SEWAGE DISPOSAL SYSTEM

DEPARTMENT OF HEALTH AND MENTAL HYGIENE

SUBDIVISION Fulton Manor LOT 7 ROAD 12300 Carol Drive

PROPERTY OWNER Gary and Susan Amey

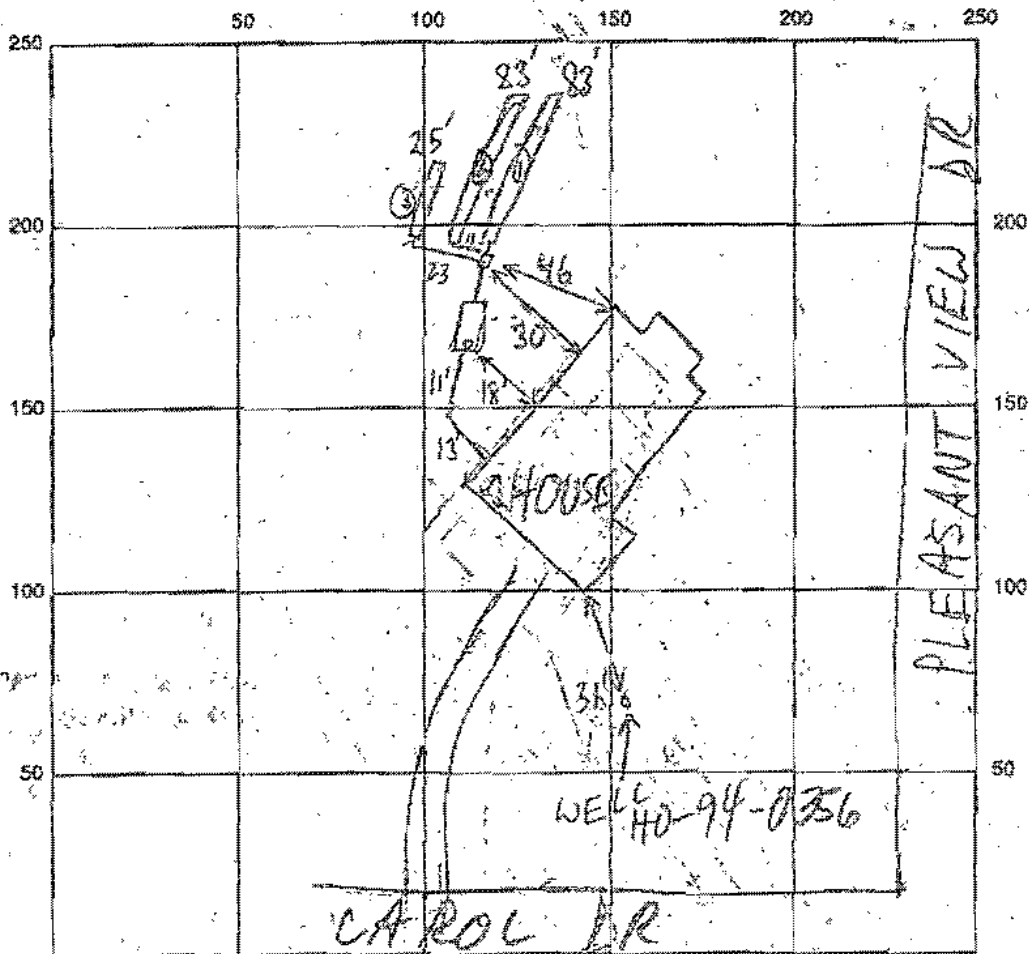
SEPTIC TANK LEVEL 1250 GAL CLEANOUTS S.C.T. - OK

DISTRIBUTION BOX LEVEL OK - BAFFLE IN

REMARKS: 12/14/95 ADVISED INSTALLER TO INSTALL TRENCHES
OF ROUGHLY EQUAL LENGTH IN FUTURE - CONTINUE MR
12/19/95 OK TO COVER MR RS

Approved Septic System Plan
Howard County Health Department

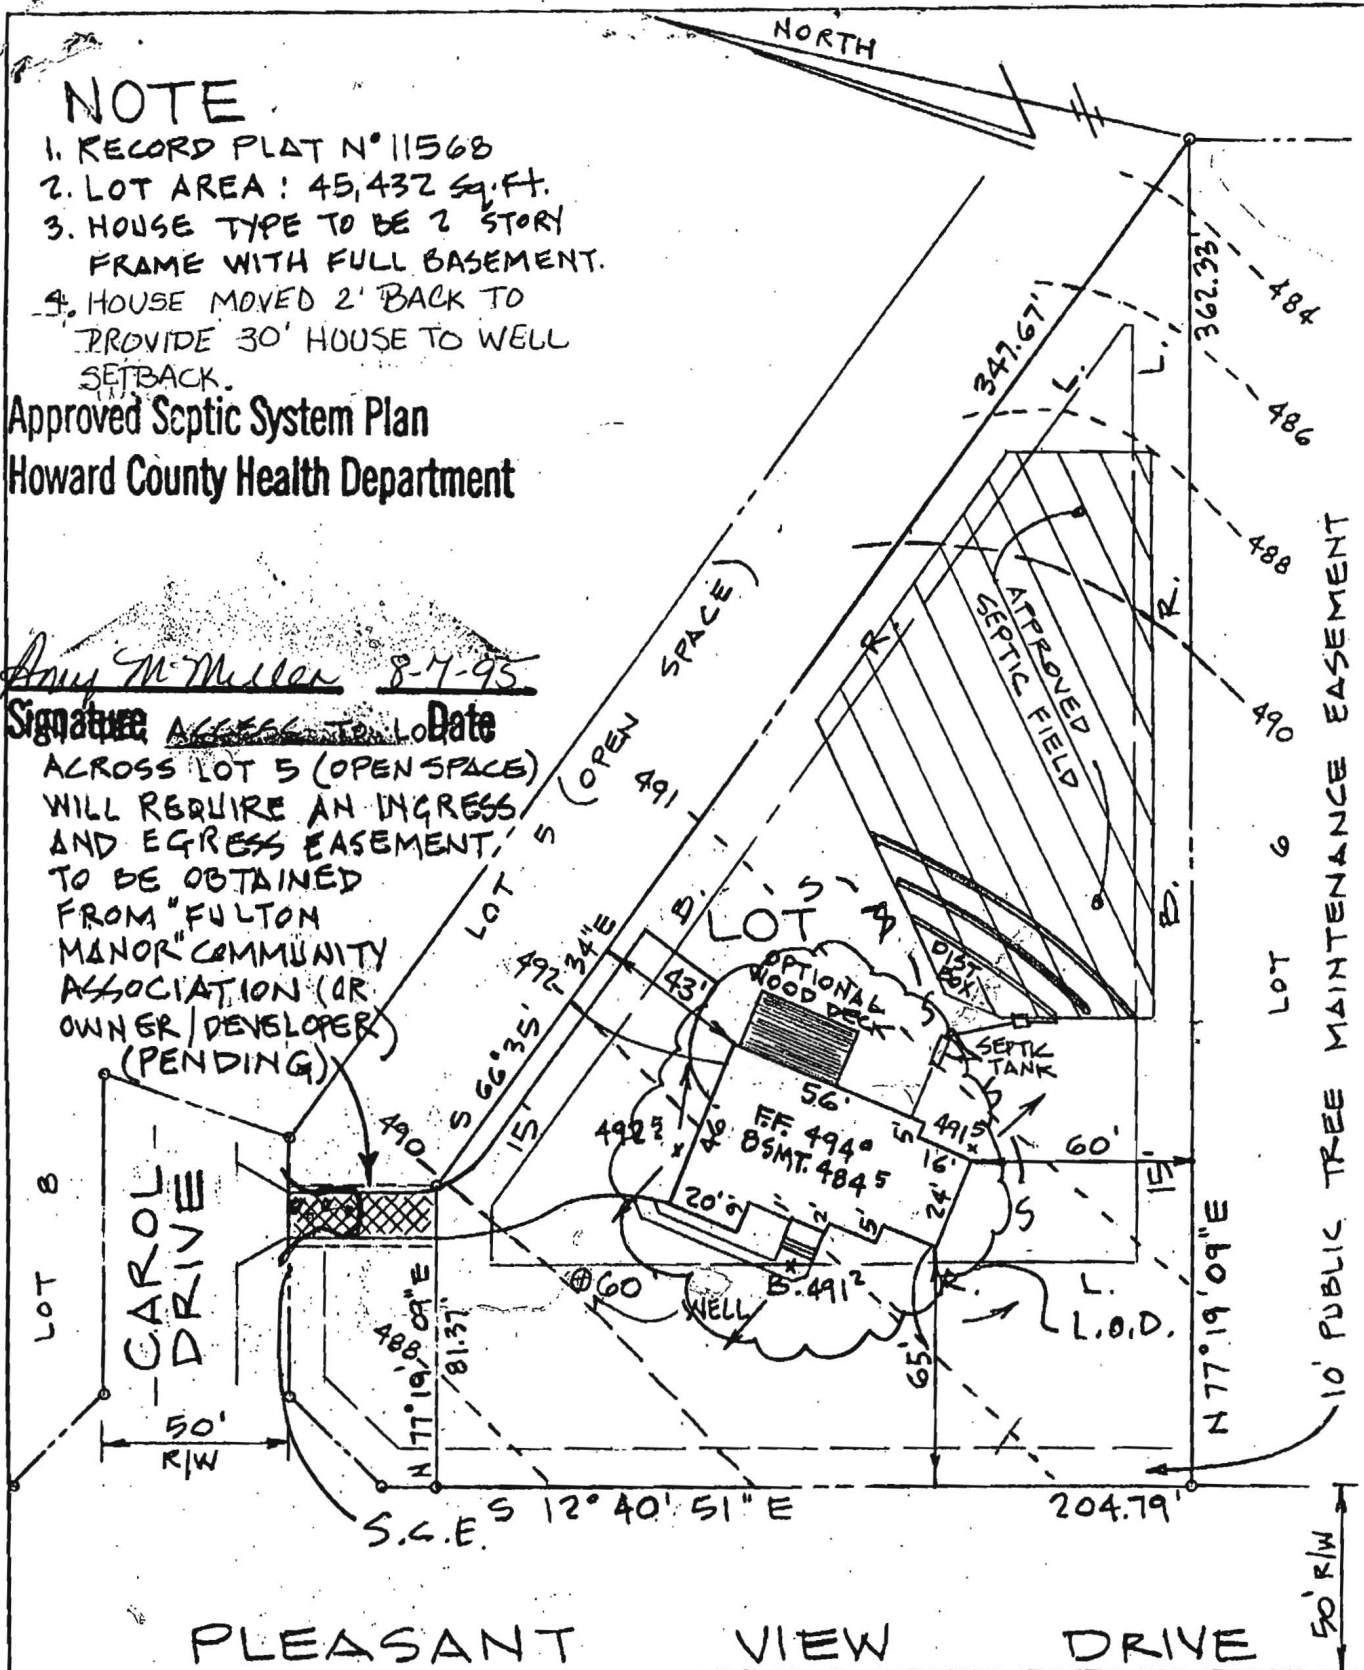
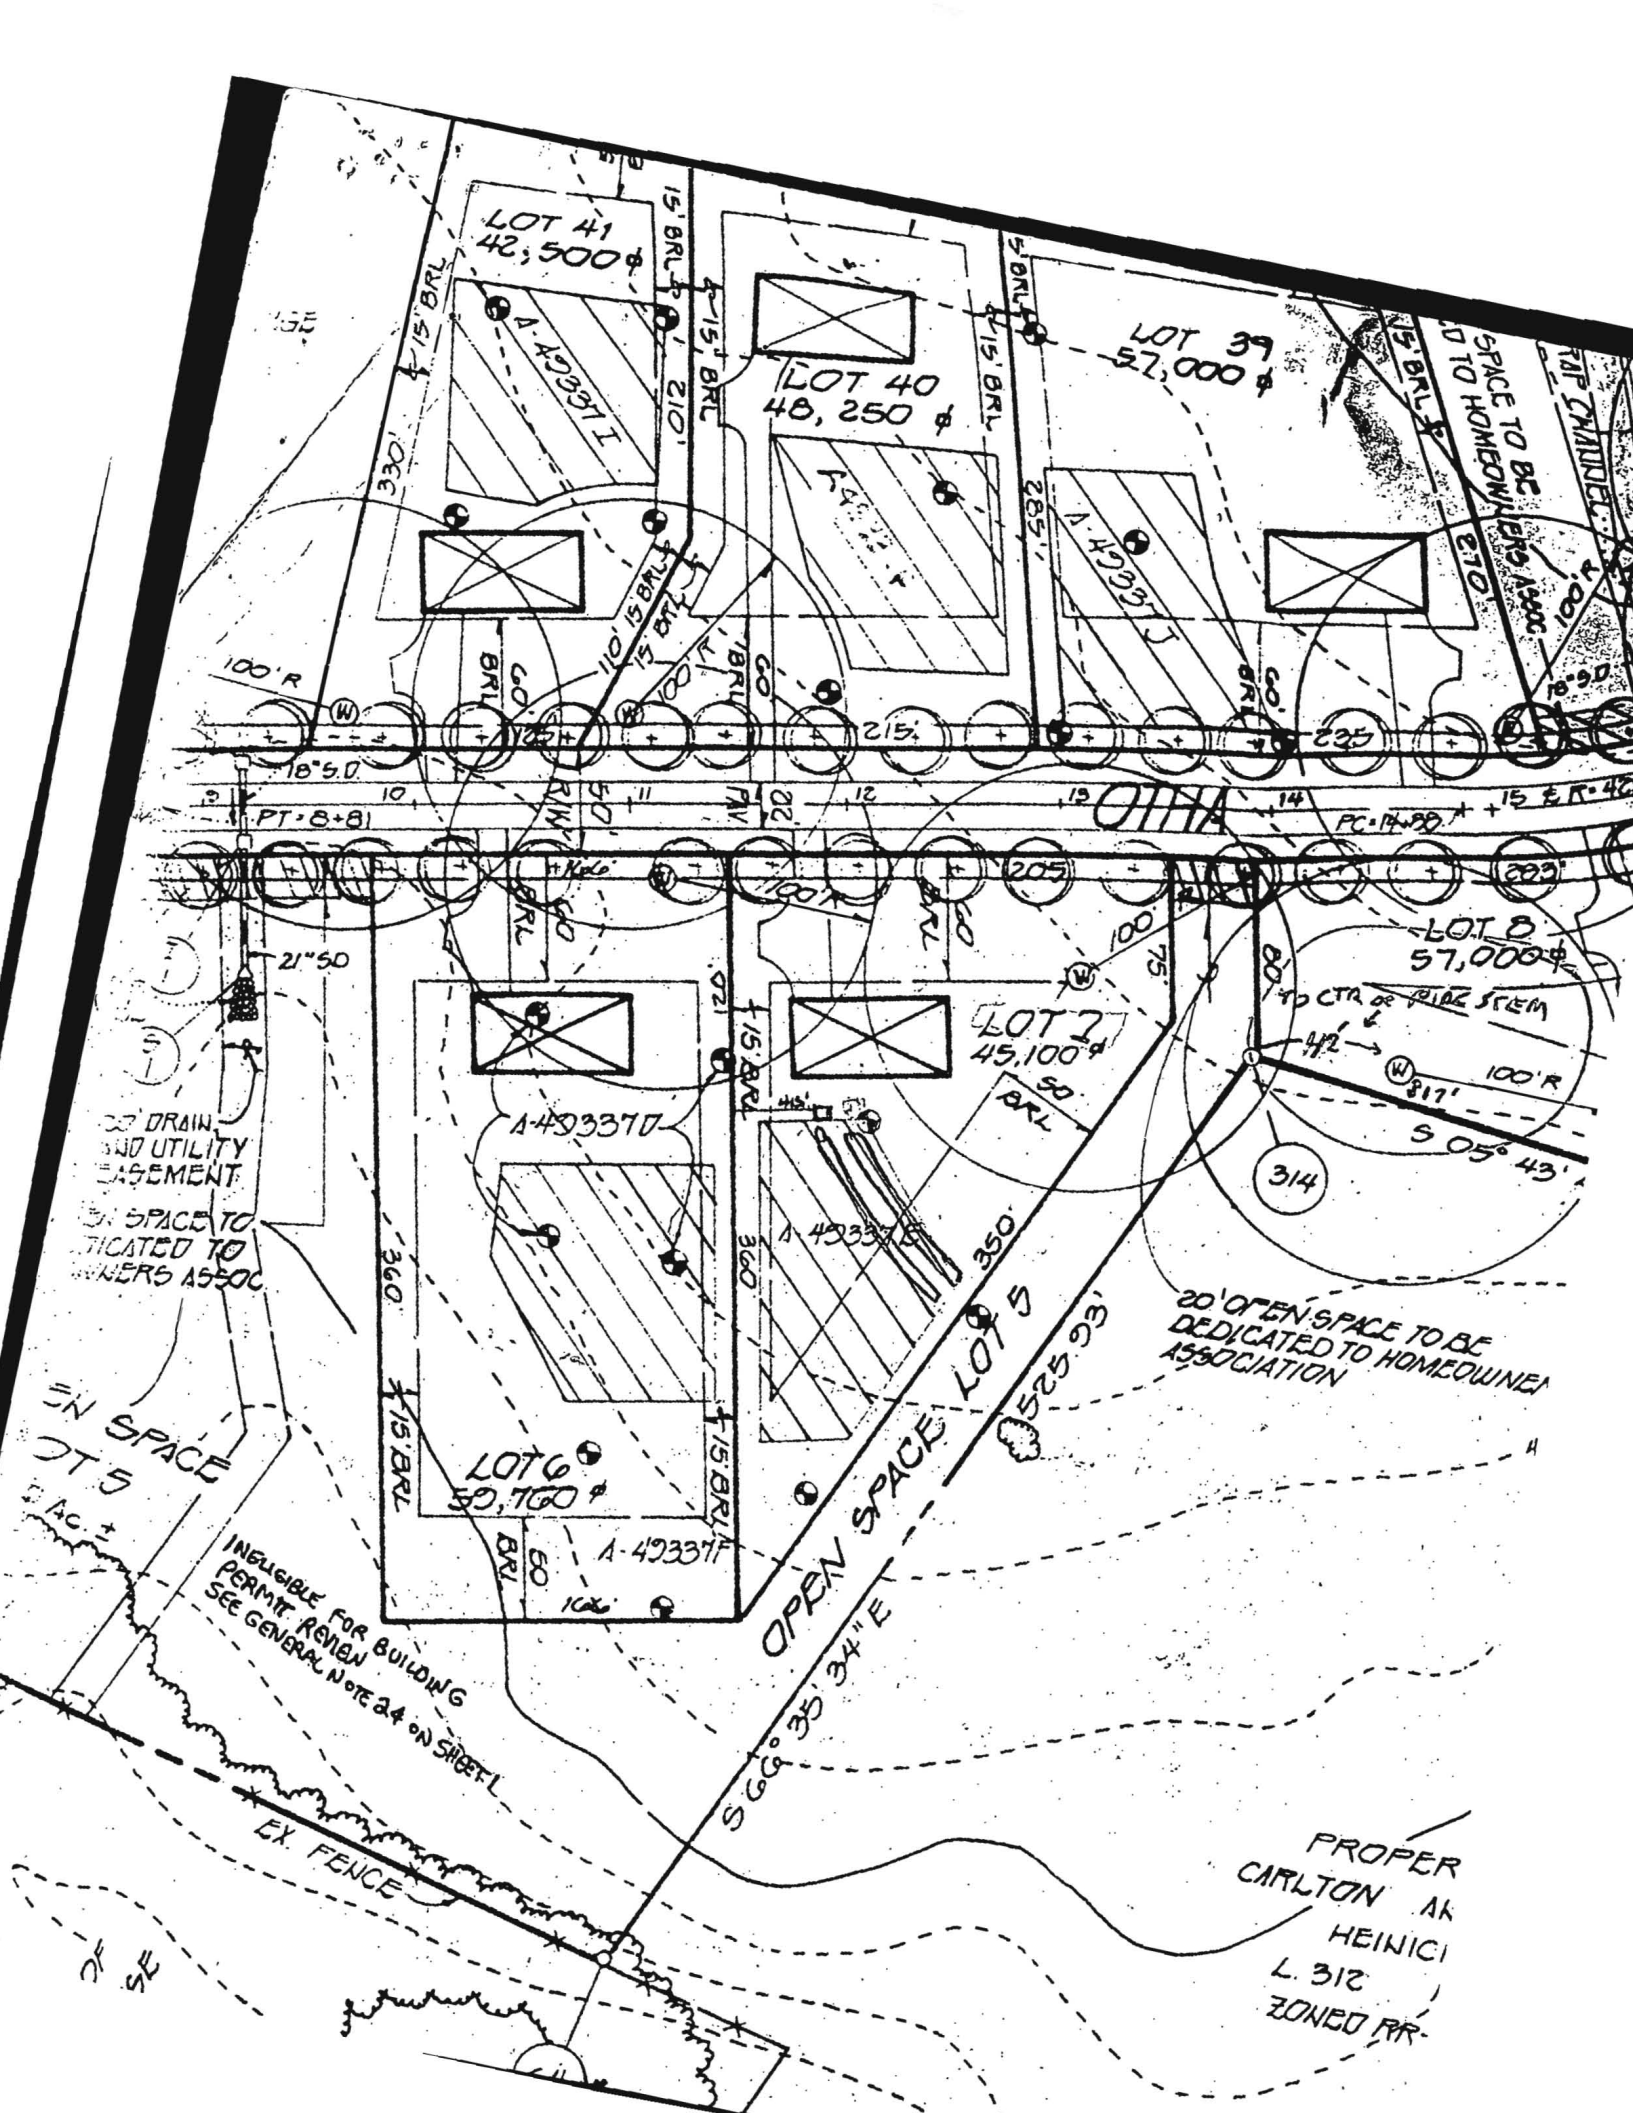
ACROSS LOT 5 (OPEN SPACE) WILL REQUIRE AN INGRESS AND EGRESS EASEMENT, TO BE OBTAINED FROM "FULTON MANOR" COMMUNITY ASSOCIATION (OR OWNER/DEVELOPER) (PENDING)

NOTE: TRENCH LENGTH TO BE DETERMINED AT TIME OF SEPTIC PERMIT ISSUANCE —

Approved Septic System Plan
Howard County Health Department

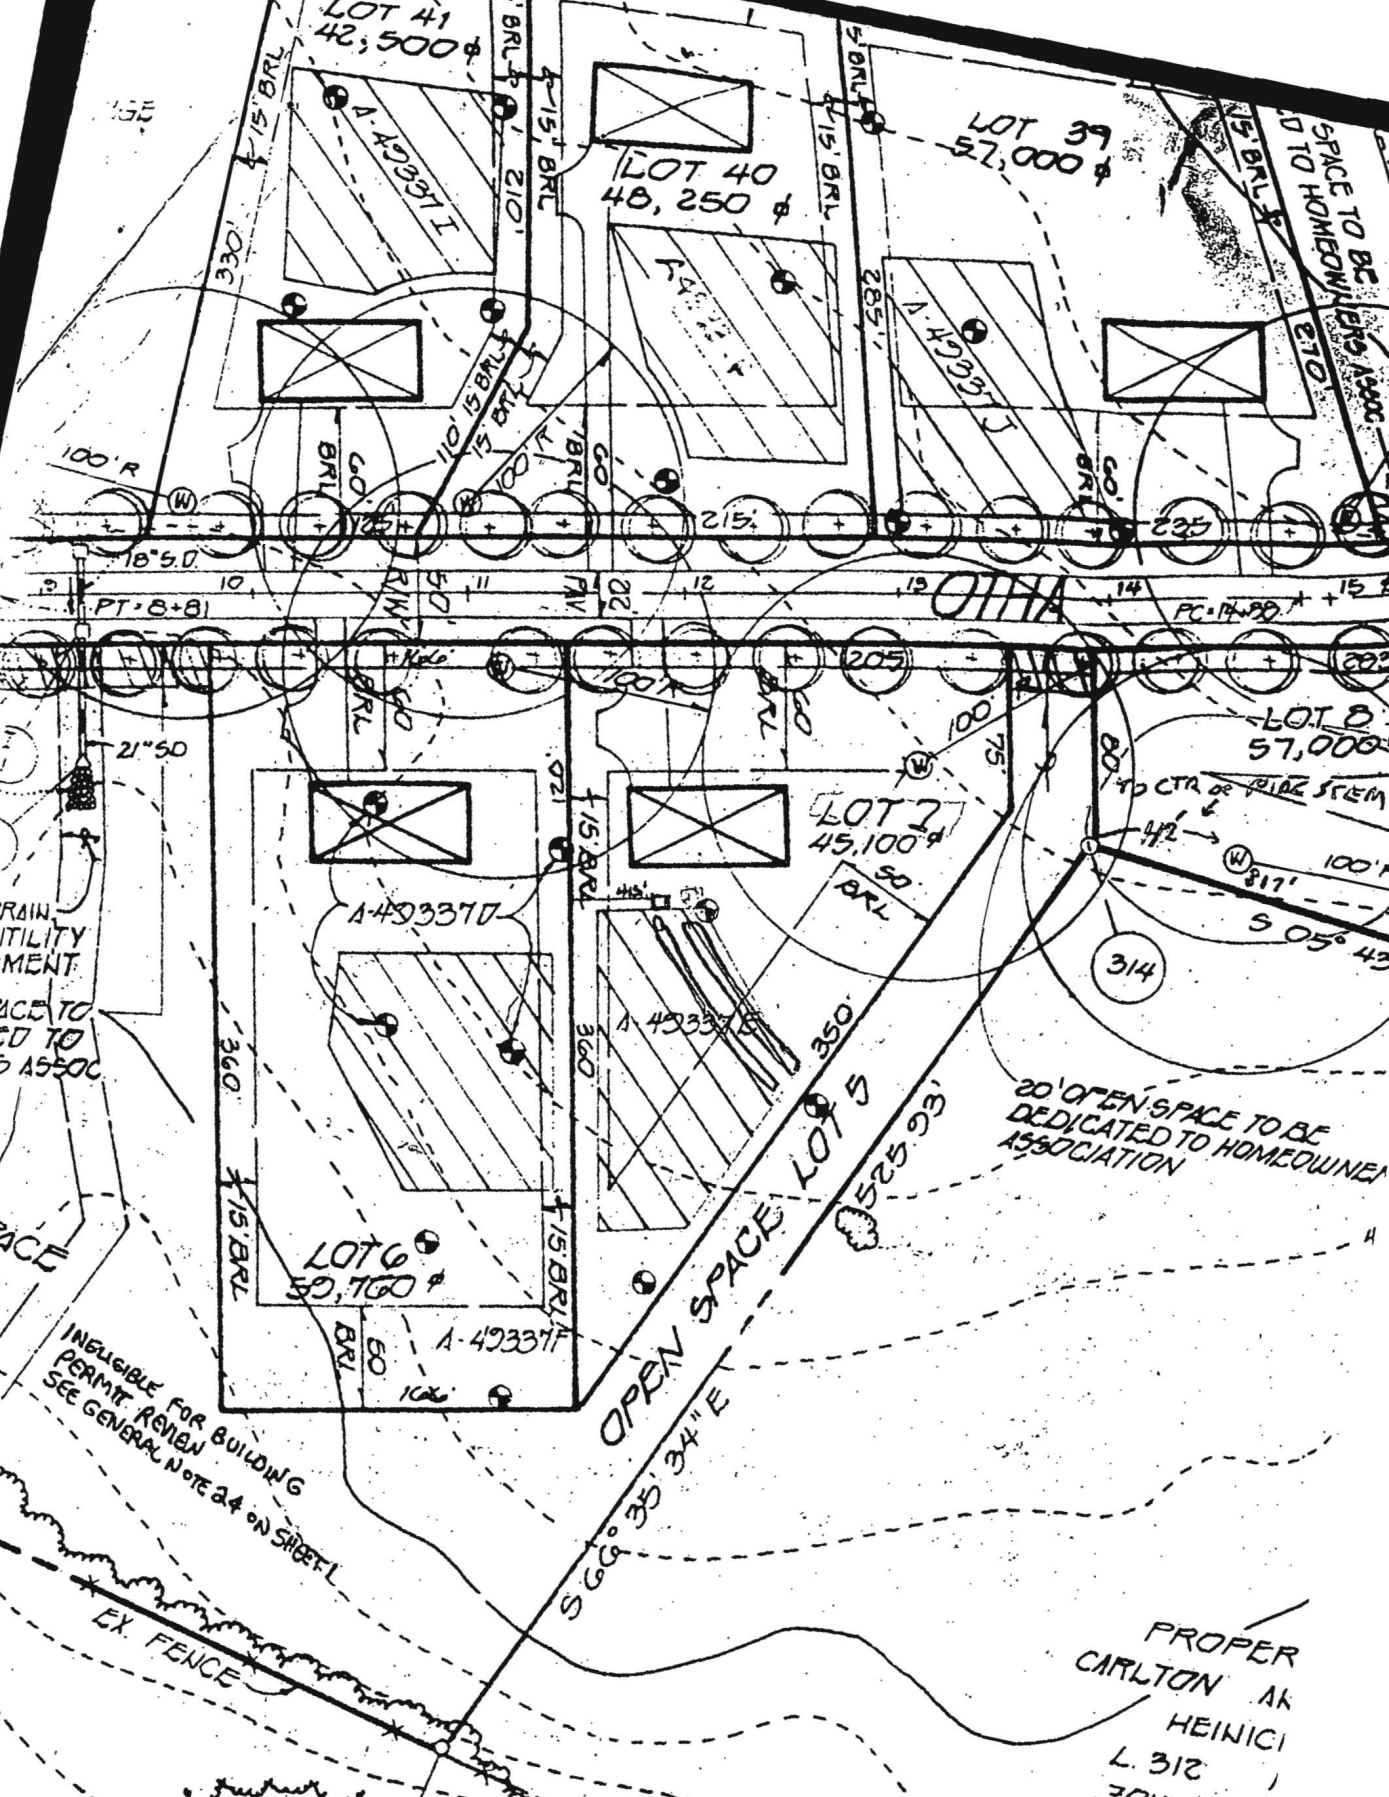
INELIGIBLE FOR BUILDING
PERMIT REVIEW
SEE GENERAL NOTE 24 ON SHEET 1

ACROSS LOT 5 (OPEN SPACE)
WILL REQUIRE AN INGRESS
& EGRESS EASEMENT,
TO BE OBTAINED
FROM "FULTON
MANOR" COMMUNITY
ASSOCIATION (OR
OWNER/DEVELOPER)
(PENDING)
